BULLETIN #154

FABRICATOR WELDMATIC 395

CONTACTOR REPLACEMENT

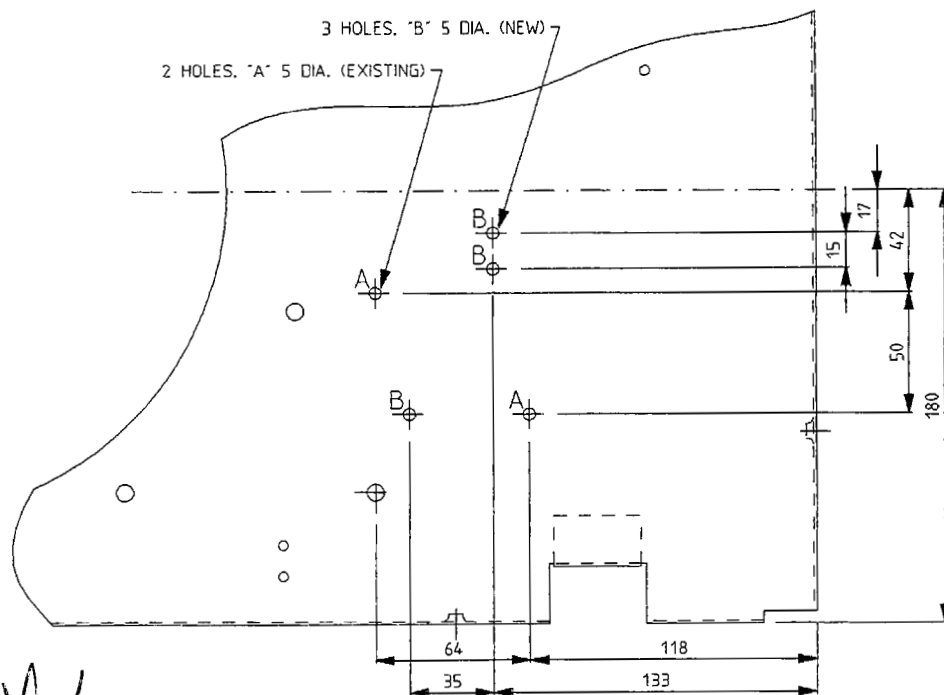
Depending on the brand of contactor used, retro fitting the new contactor to existing Weldmatic 395 will require two additional holes to be drilled in the shelf panel. Refer to the diagram below for new mounting hole locations (marked "B").

Note : Holes marked "A" are existing holes
